FINAL
Coal Ash Impoundment -
Specific Site Assessment Report
Arizona Public Service
Four Corners Power Plant

September 2009
Project 091330

This report presents the results of a specific site assessment of the dam safety of Lined Ash Impoundment (LAI) embankment dam and Lined Decant Water Impoundment (LDWI) embankment dam at the Four Corners Power Plant in Fruitland, New Mexico. This assessment was performed on May 19th and 20th of 2009.

| NO. | DATE | REVISION | DWN | CHD | EXD | RWD | APVD | W.A. |
|---|---------|--|------|------|-----------|--------|-------|------|
| FOUR CORNERS COMMON ASH HANDLING SYSTEM LINED ASH IMPOUNDMENT 5258 LIFT NEW 10' DROP INLET PIPE PLAN & SECTION | | | | | | | | |

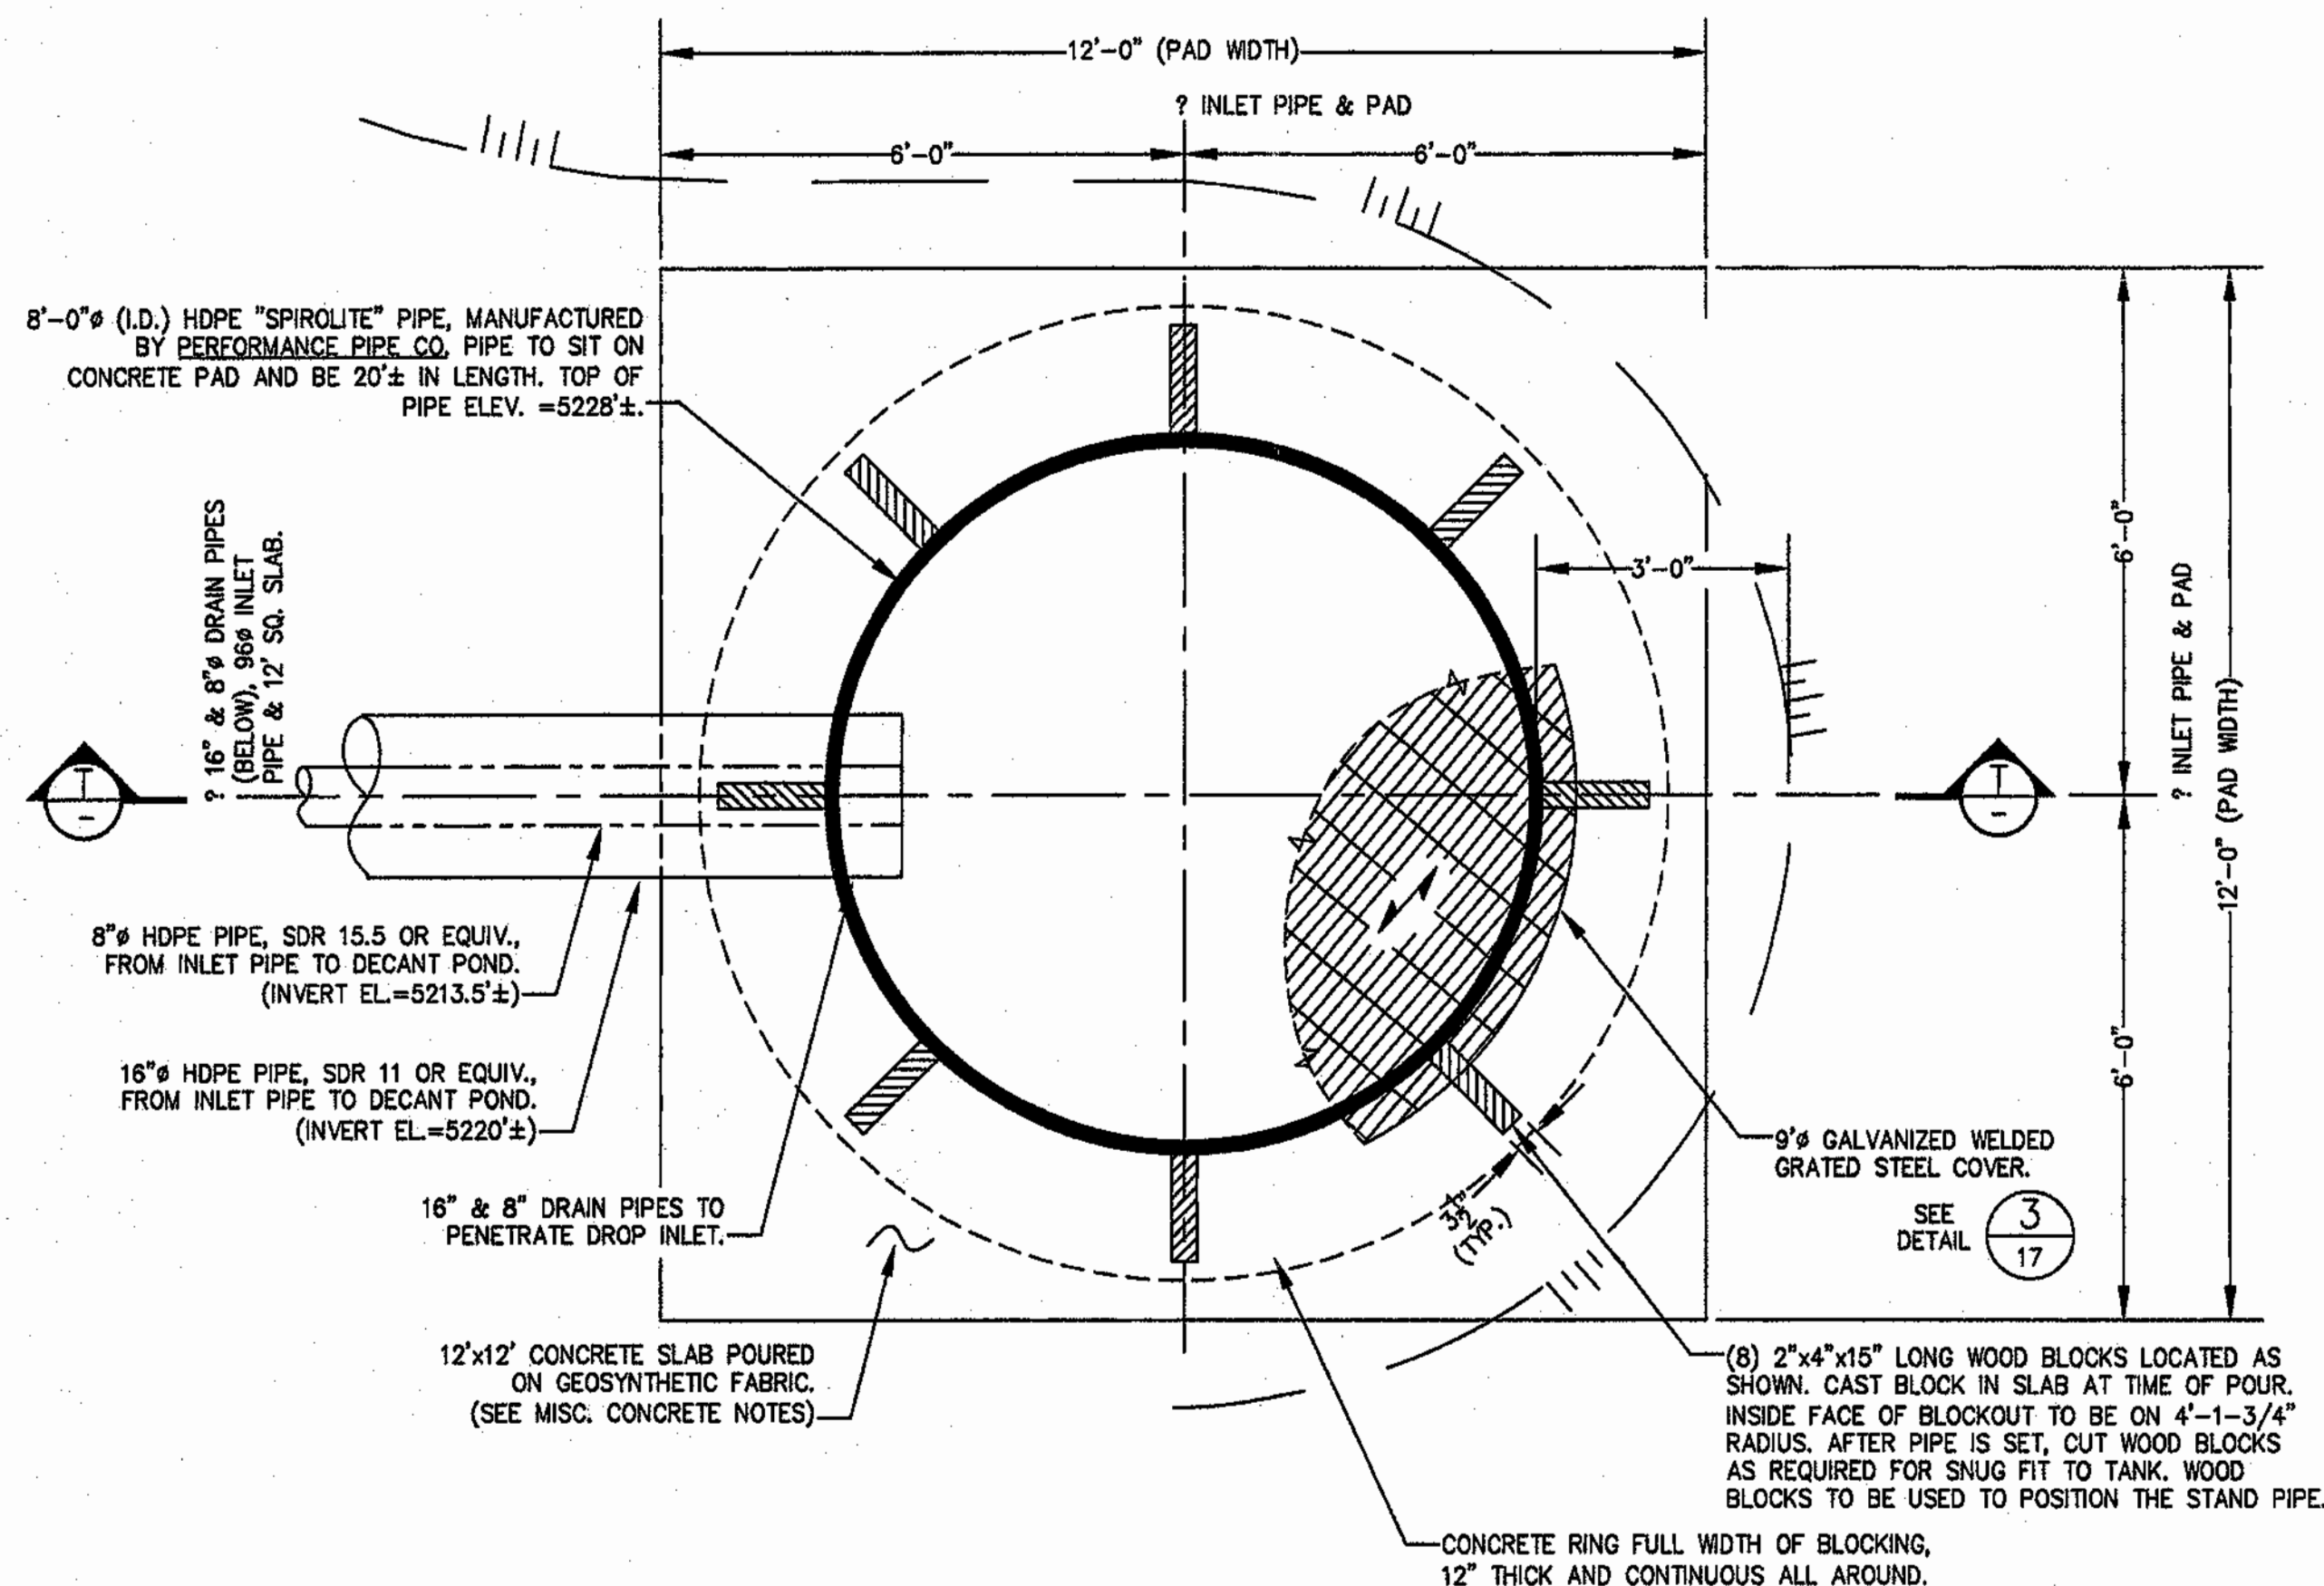
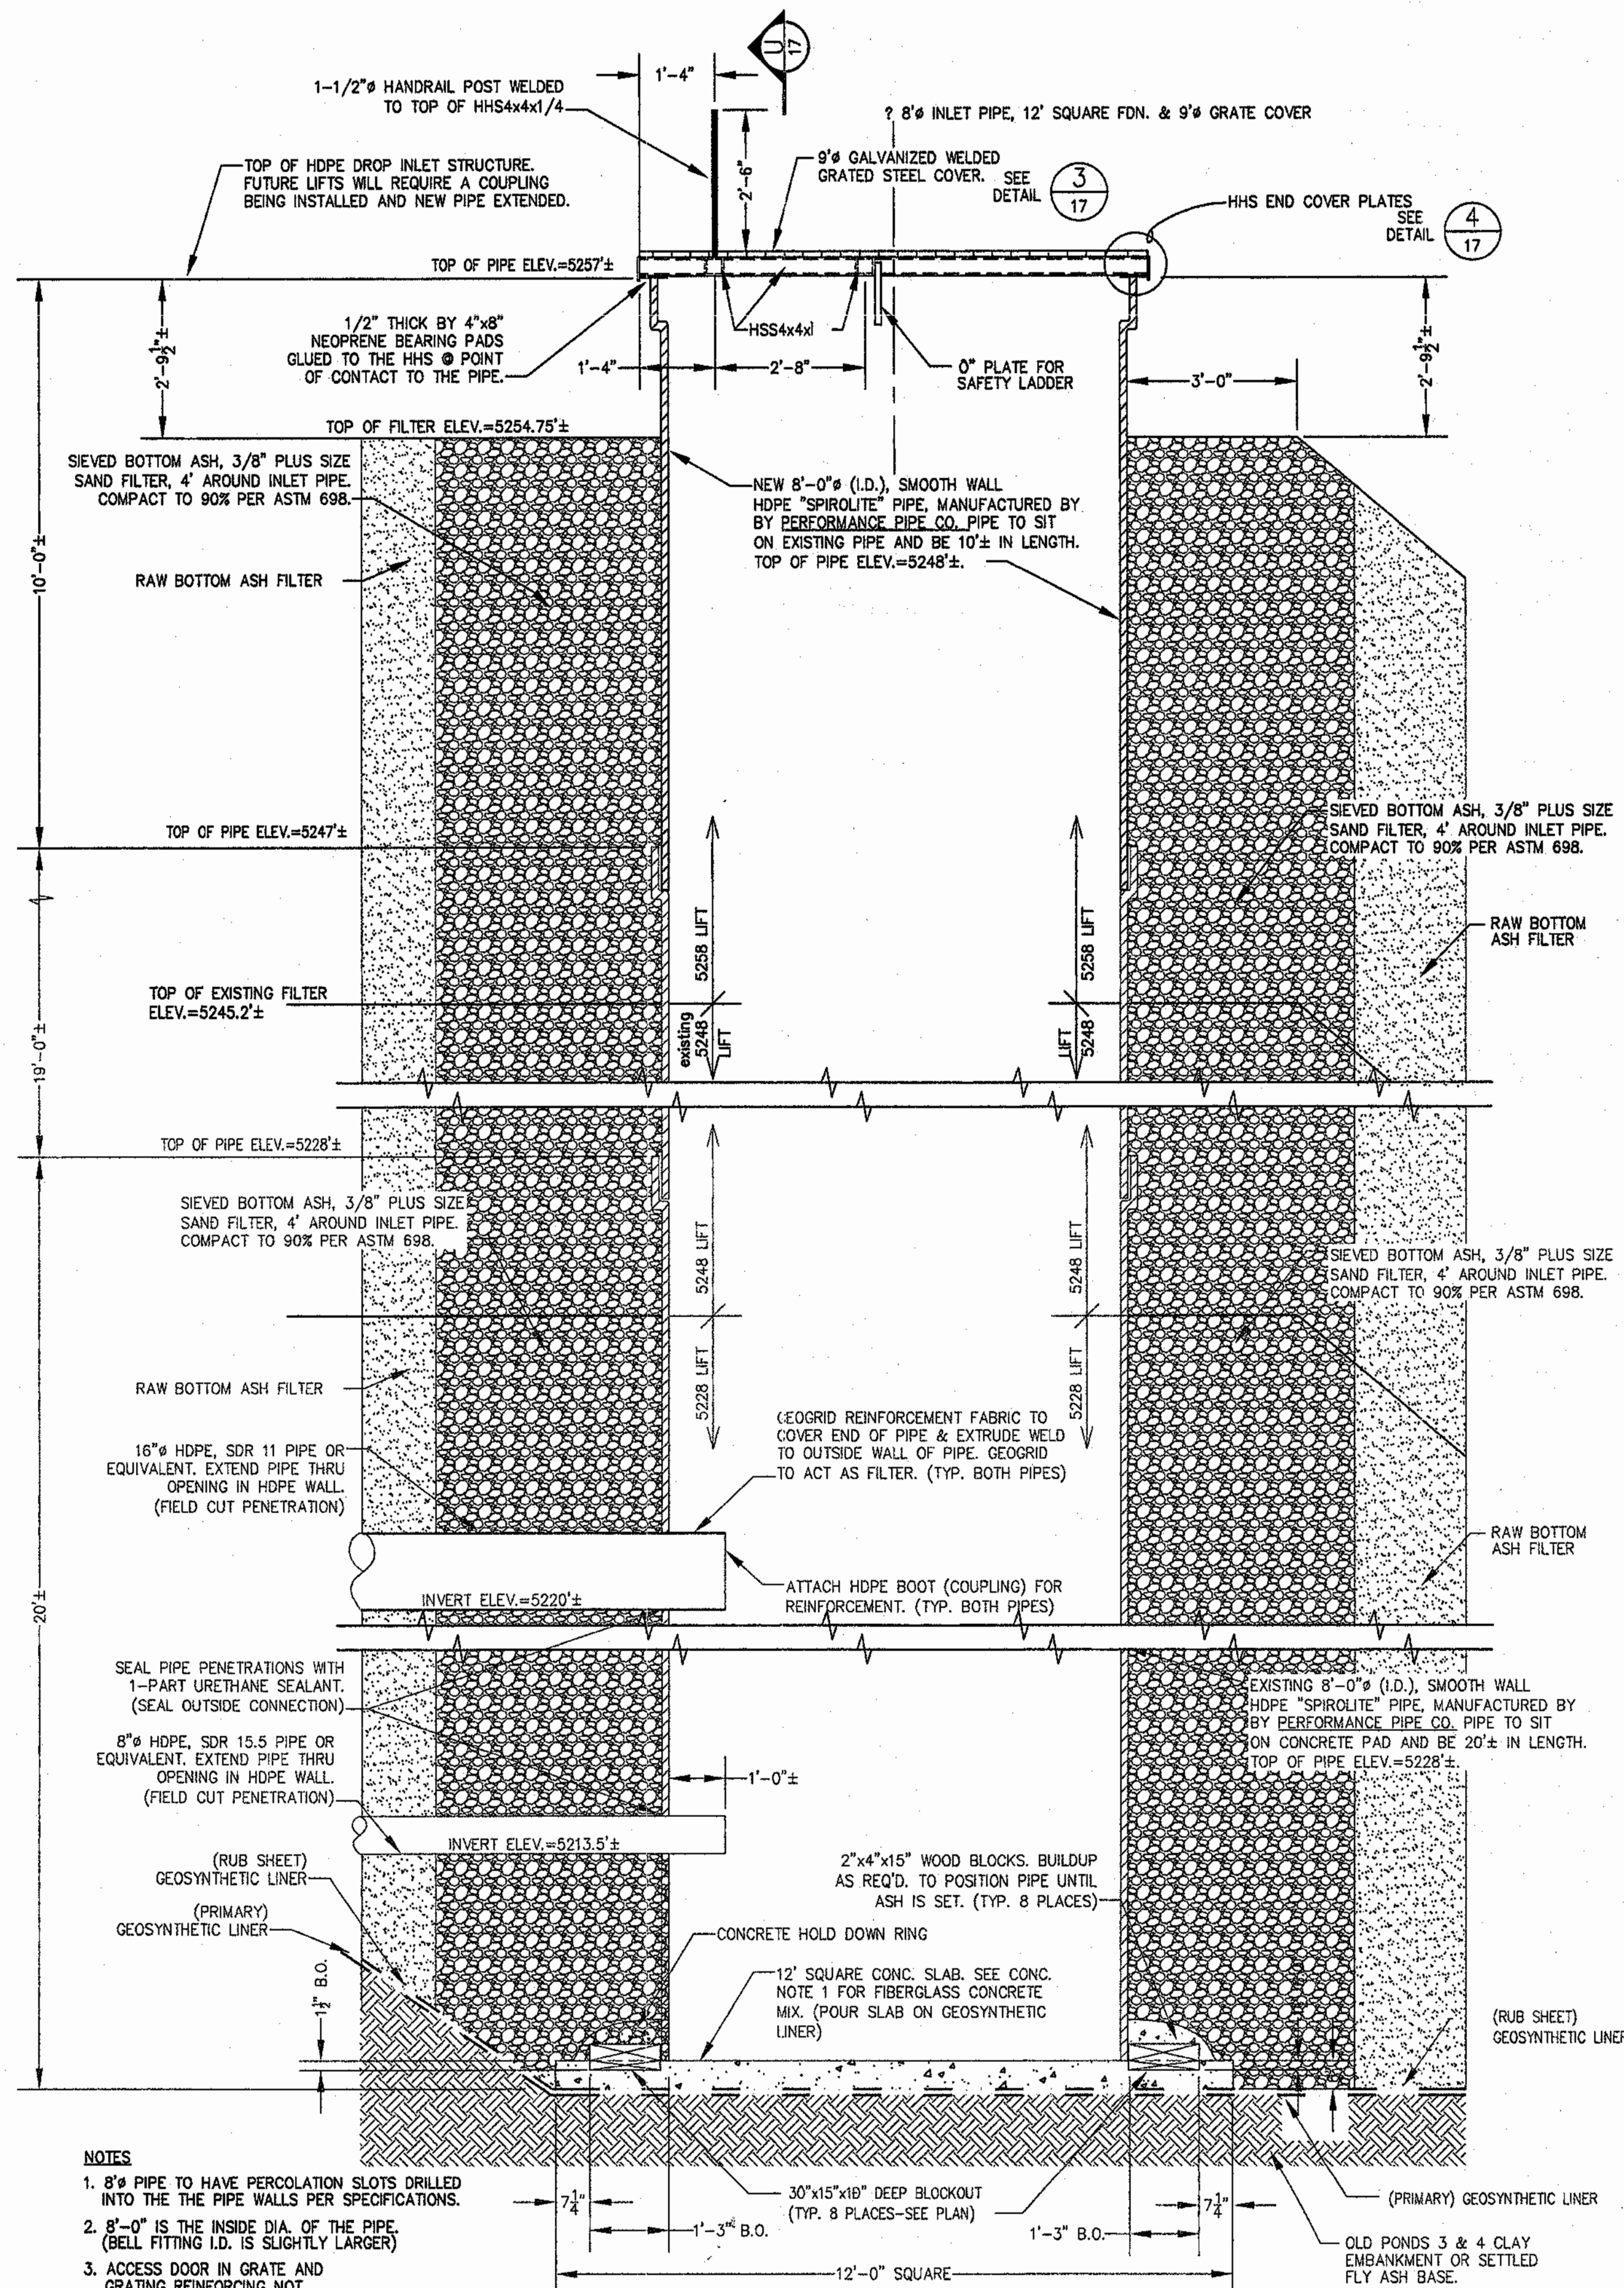
1. Perform a structural analysis that includes a sensitivity analysis of the HDPE decant drop inlet structure to varying water depth and the influence of multiple penetrations of the manhole sides. Evaluate the decant structure for potential for differential movement between the manhole riser and the foundation slab. Provide protection for the exposed part of the manhole from impacts from vehicles or large equipment.
